# DOCUMENT CHANGE NOTICE (DCN)

DOCUMENT No. (DOC-REV-GP. ID)	TITLE	NEW REV.
D960133-D-D	Large Optic Suspension Structure Assembly	E
D970551-C-D	Recycling Mirror LOS Structure Assembly	D
D960145-A-D	LOS Height Adpater Assembly	B

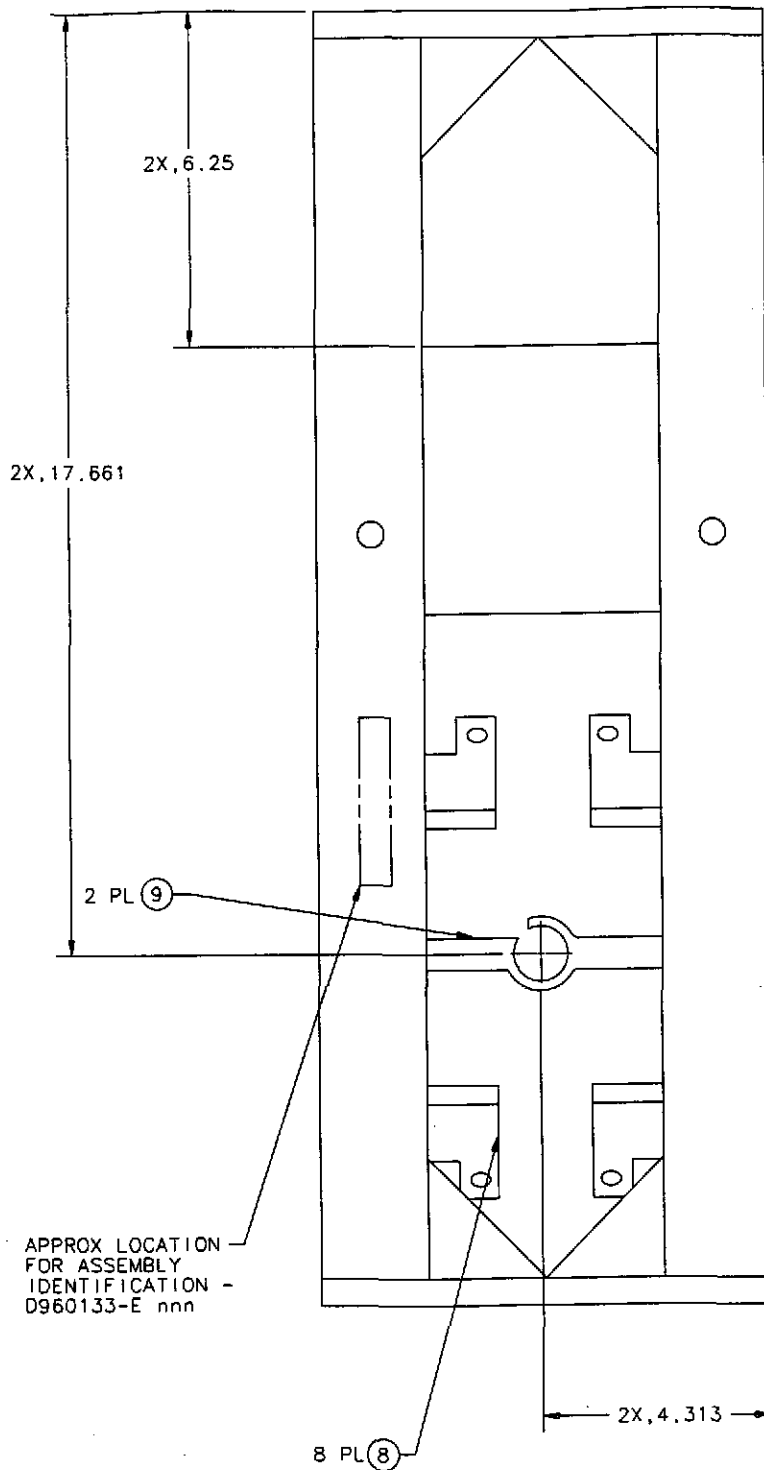
CHANGE DESCRIPTION (FROM/TO): Indicate position of assembly identification.

See attached sheets for this placement definition.

REASON FOR CHANGE: Subcontractor wants position of assembly identification clearly defined.
